# BALTIMORE COUNTY PUBLIC SCHOOLS

## ADDENDUM NUMBER \_\_4\_\_

DATE: December 12, 2016  
BID NAME: REPLACEMENT OF VICTORY VILLA ELEMENTARY SCHOOL  
BID NUMBER: ARA-209-17  
DUE DATE: **DECEMBER 21, 2016**  
DUE TIME: **2:00 P.M.**

2 SEATING AREA STAIR SECTION (NORTH PATIO)  
 3/8" = 1'-0"

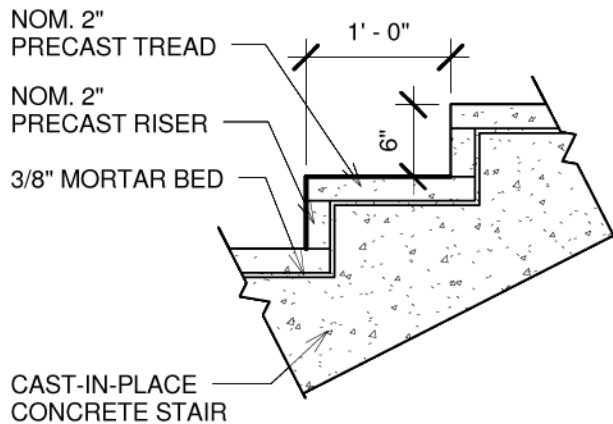
- a. Revise North Patio Stair Detail 2 in accordance with **Sketch A503 1 of 9**.

G5 WALL TYPE AND DETAILS  
SCALE: 1" = 1'-0"

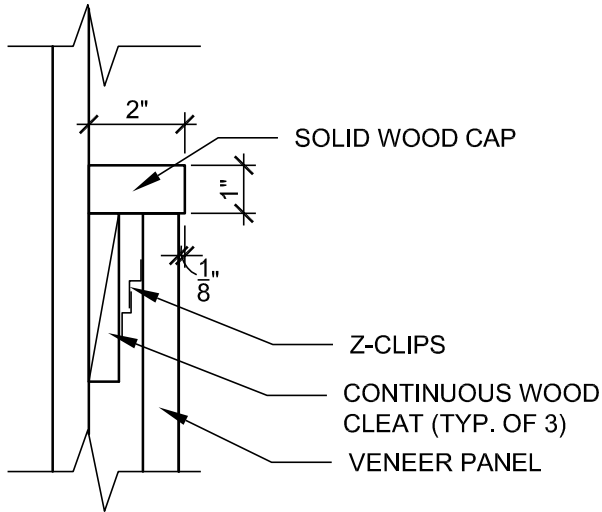
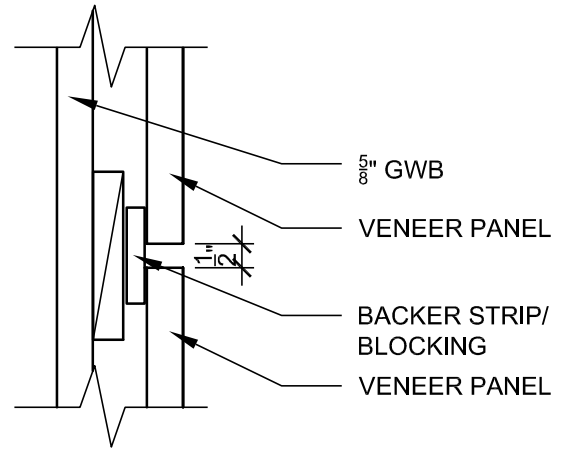
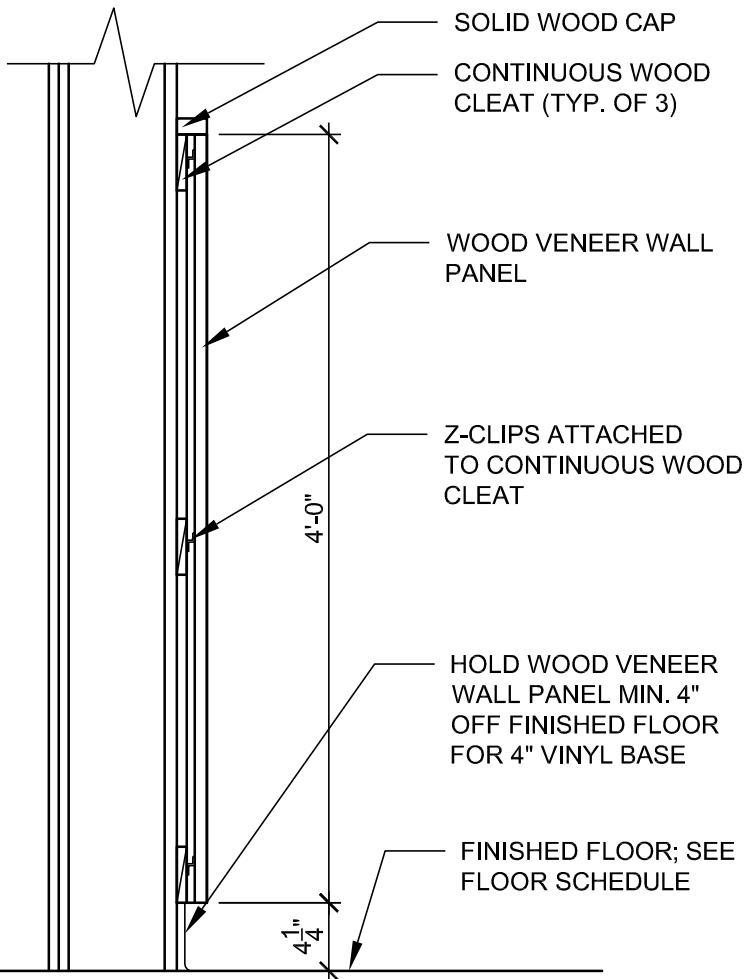
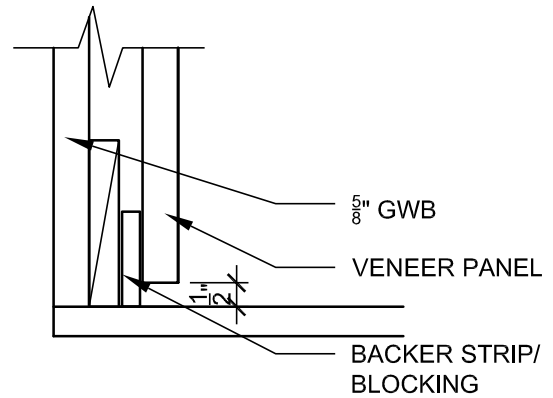
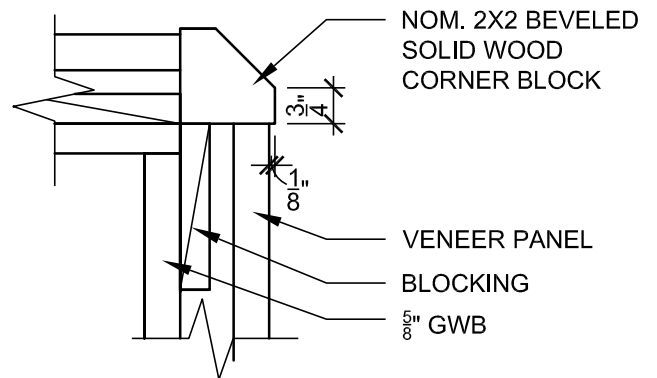
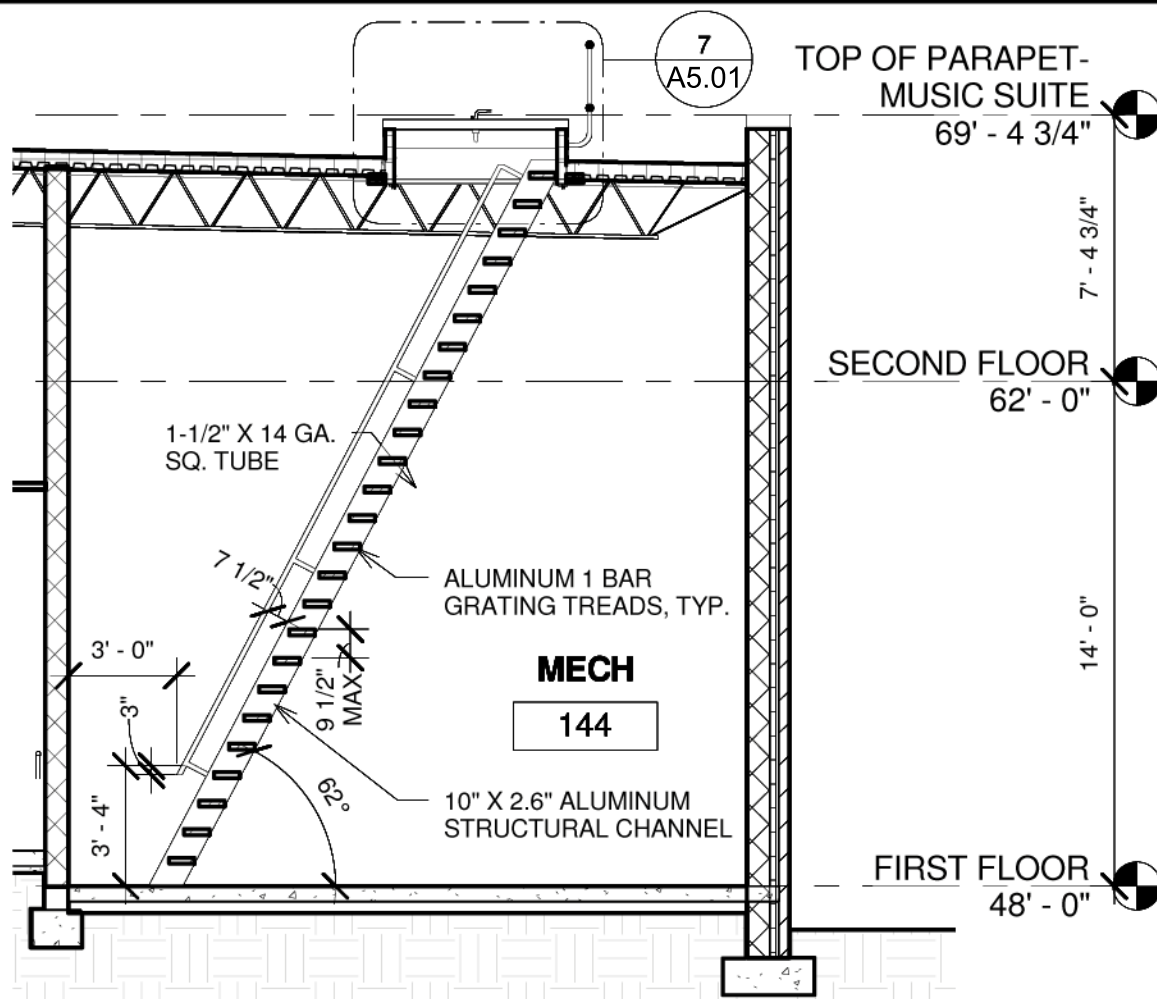
- a. Add "G5" Wall Type - Section and Details for Alternate Wood Paneling in Corridors in lieu of ceramic tile, per **Sketch A608/Alt 1 of 1**.

10 MECH. 144 SHIP'S LADDER - SECTION  
3/16" = 1'-0"

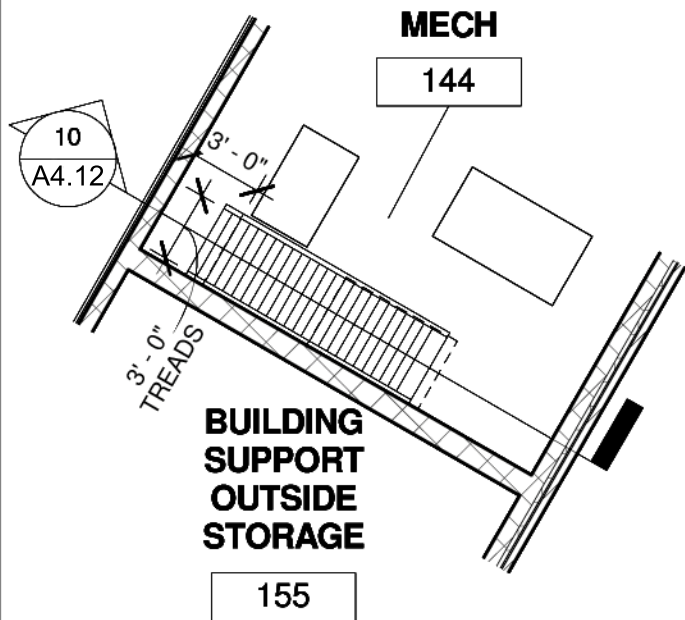
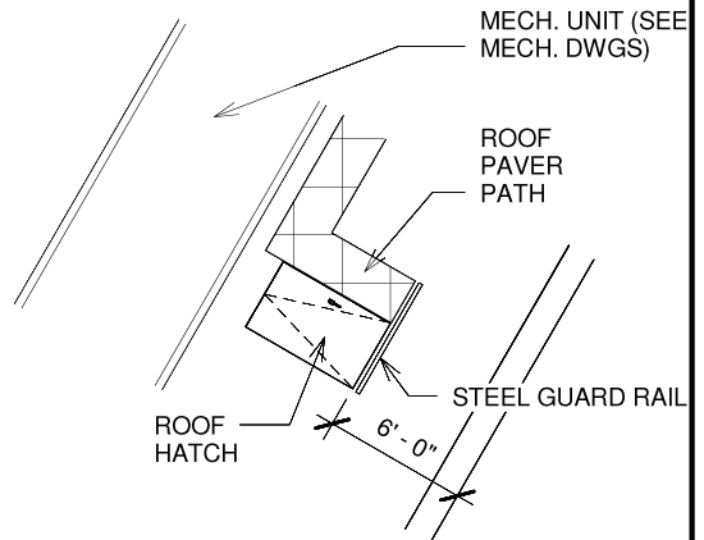
- a. Add note at roof access stair shown in Mechanical 144 - "Roof Access Ships Ladder – See 9/A412". Refer to **Sketches A412 and A501, 2 and 3 of 9**.
- b. Add Canopy north of Mechanical 144/Can Wash 154, with note – "Canopy - See 2/A103". Refer to **Sketch A103 8 of 9**
- c. At wall enclosure around Operable Partition storage pocket at Gym. 140/Caf.141, change Wall Type from B1 to C1 (8" CMU) per Structural Dwgs. Maintain interior dimension of pocket, align Corridor 007 face of CMU wall with continuing frame and GWB wall in Corridor, and adjust dimension of PE-Inst. 140E as necessary.
- d. Add note at stair landing outside Door 143B from Elec. 143 – "Conc. Stair and landing – See 2/A105". Refer to **Sketch A105 9 of 9**

- a. At Detail 7, add note to indicate that “Wall and ceiling enclosure of Storage 158 under Stair ST2 shall be 1-hour UL-rated assemblies.
- b. Add Mech. 144 Ships Ladder Detail and similar Custodial 229 Ships Ladder Detail, per Addendum 4 **Sketch 2 of 9** to this Sheet as Detail 9.

4 Curb Detail REVISED  
1" = 1'-0"

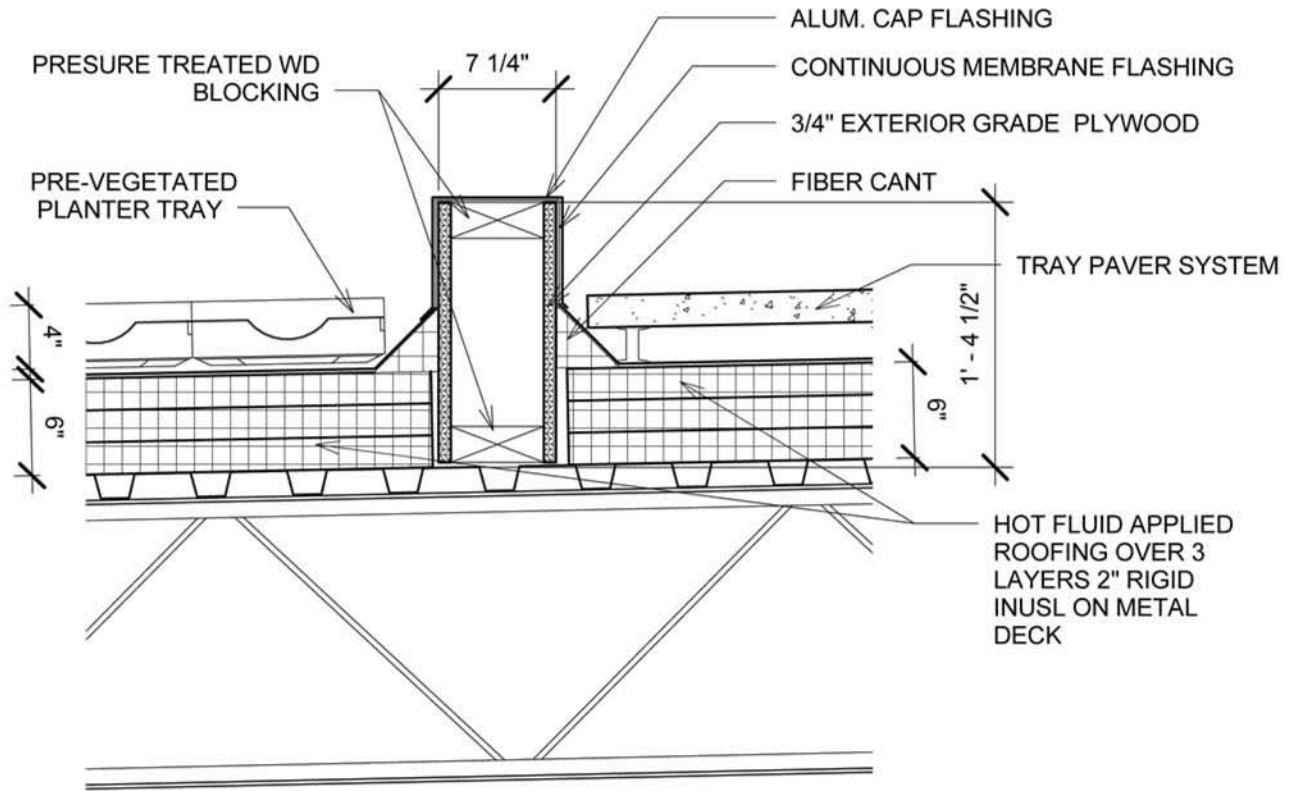
- a. Revise Roof (Curb) Detail 4 in accordance with **Sketch 4 of 9**.
- b. Revise Roof (Bench. Planter) Details 5 and 6 in accordance with **Sketch 5 of 9**.

**C0.01**

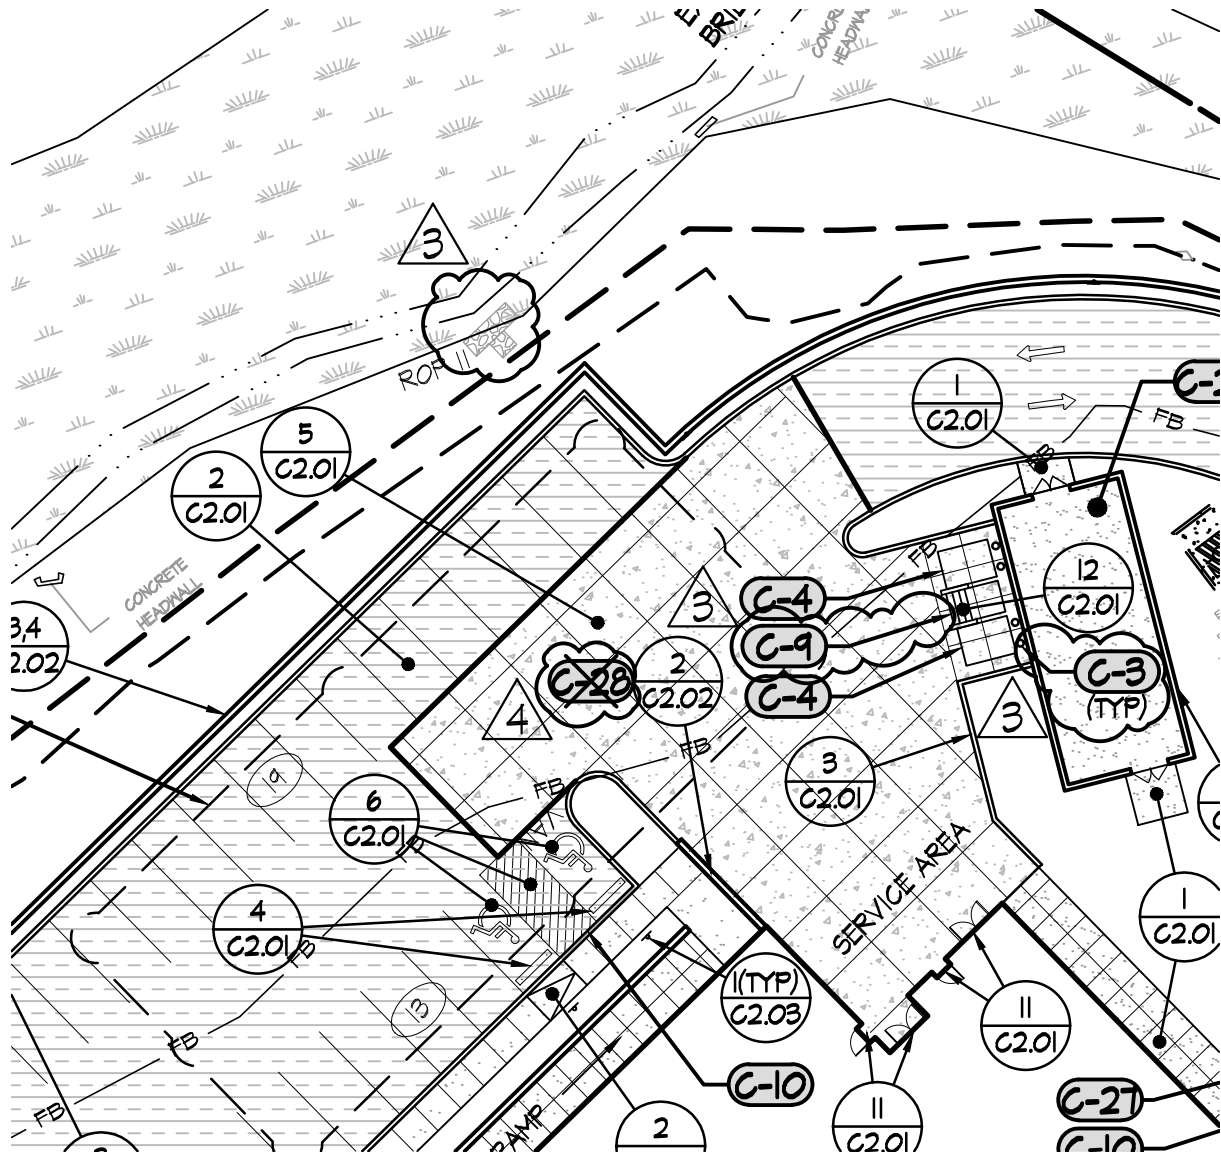
- a. **ADD:** Note number 3

**C1.02**  
1 OF 4

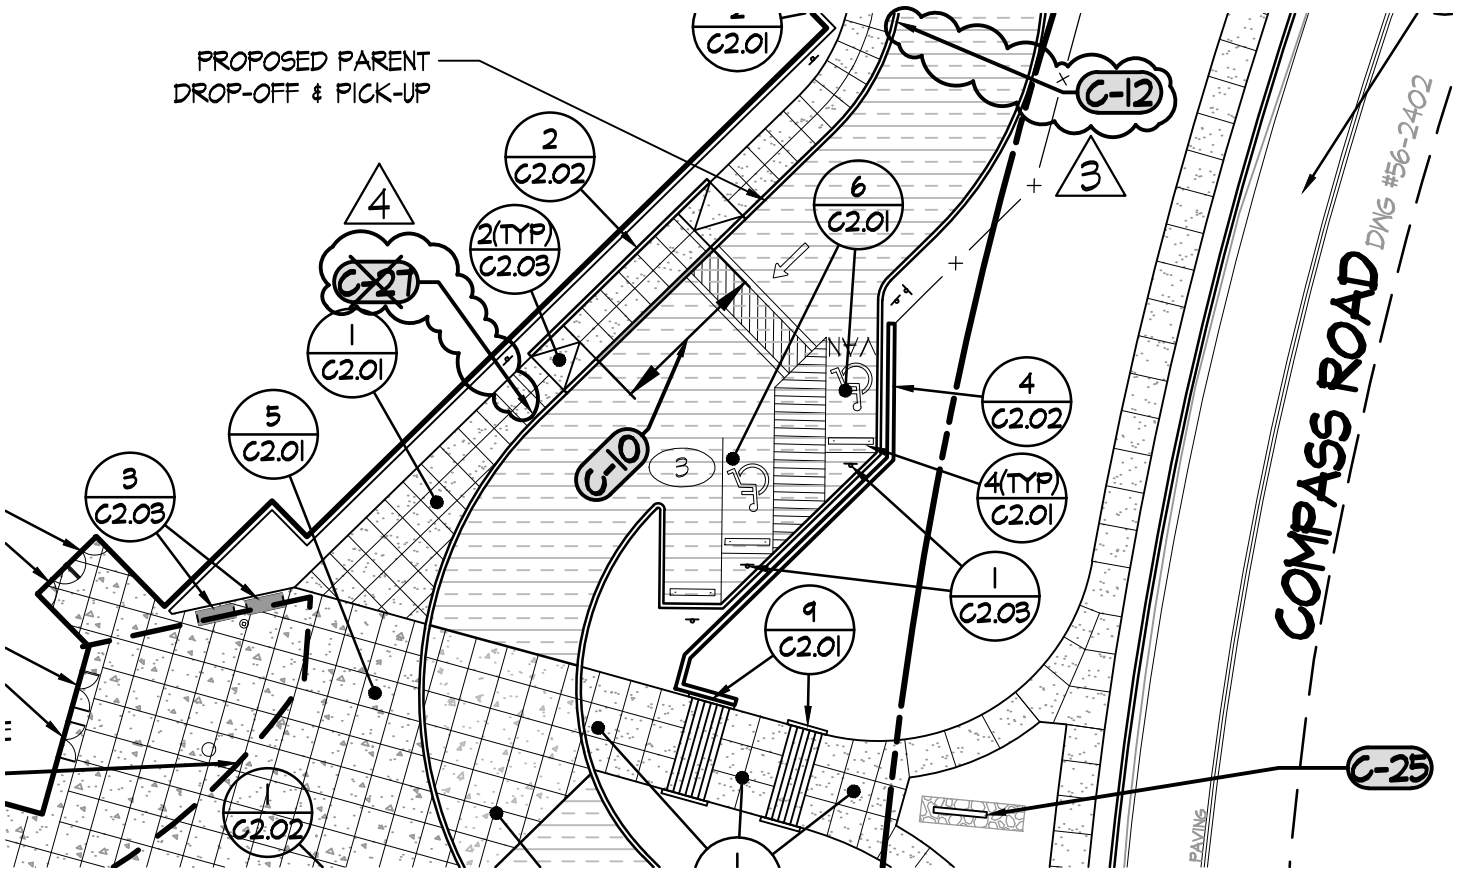
- a. **REVISE:** C-28 "Proposed canopy".
- b. **DELETE:** C-27 callout in parent drop-off area.
- c. **DELETE:** C-31 callout in bus loop.
- d. **REVISE:** Note C-18, to read "Proposed playground equipment provided and installed by owner for Pre-K & K (Base Bid)"

**C2.01**  
3 OF 3

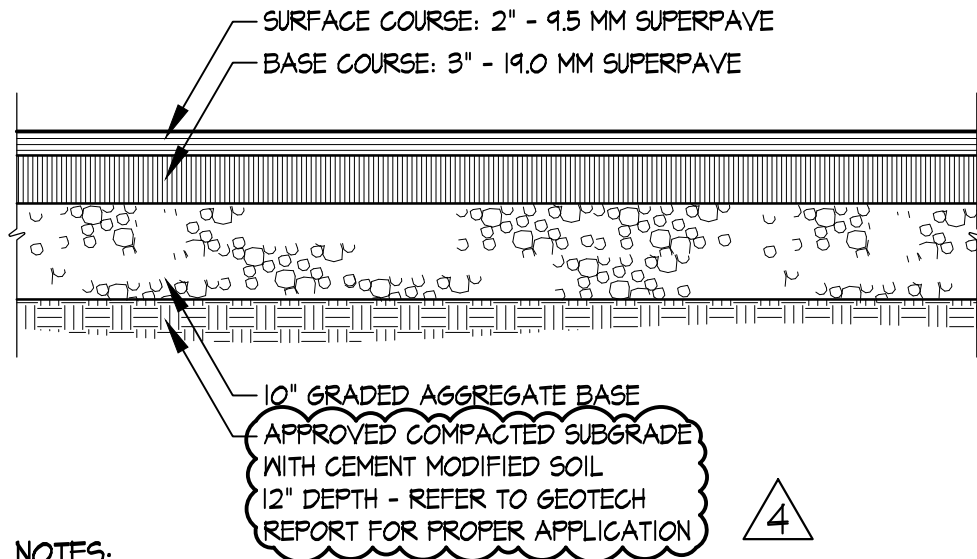
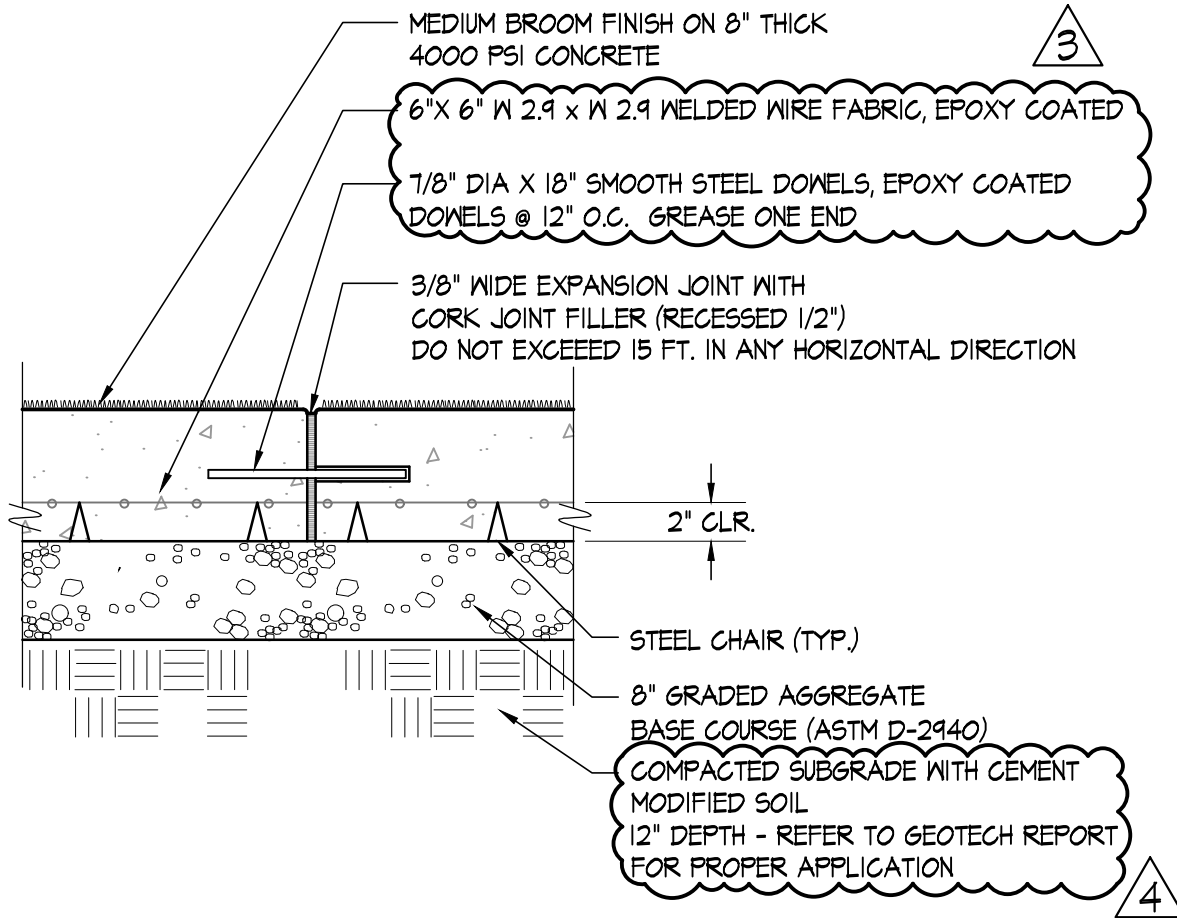
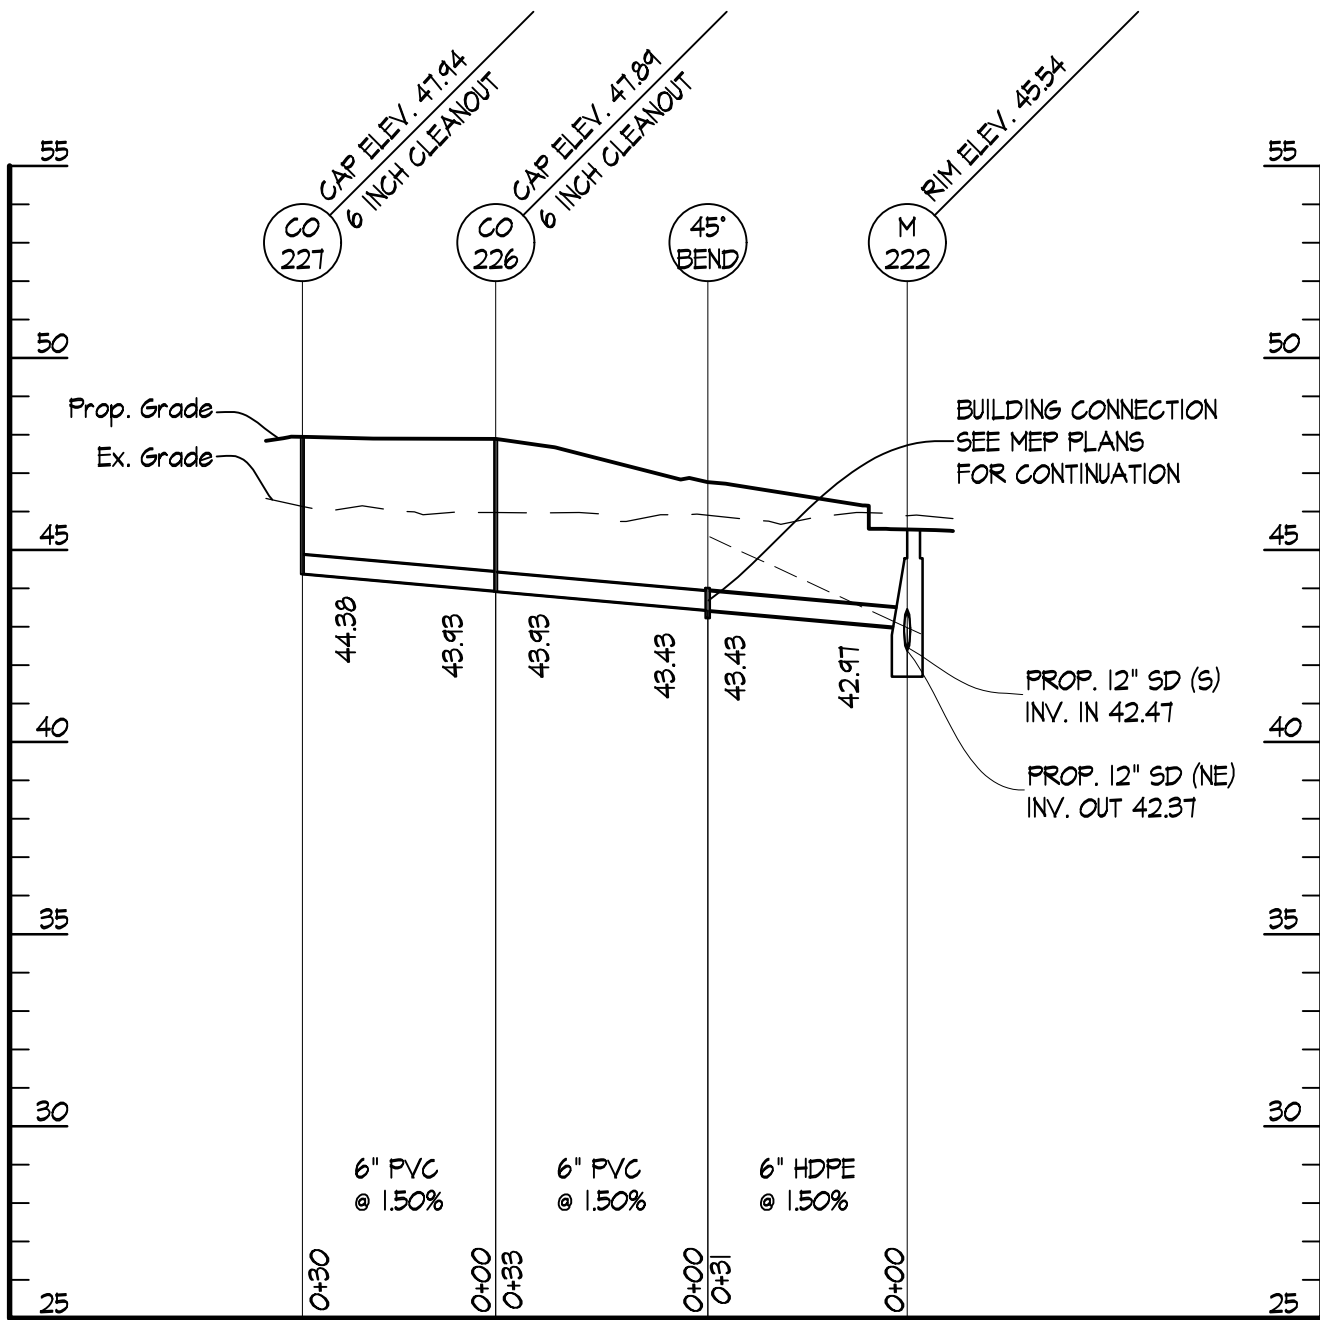
- a. **ADD:** "Refer to Geotech Report for proper application" to details 1, 2 and 5.
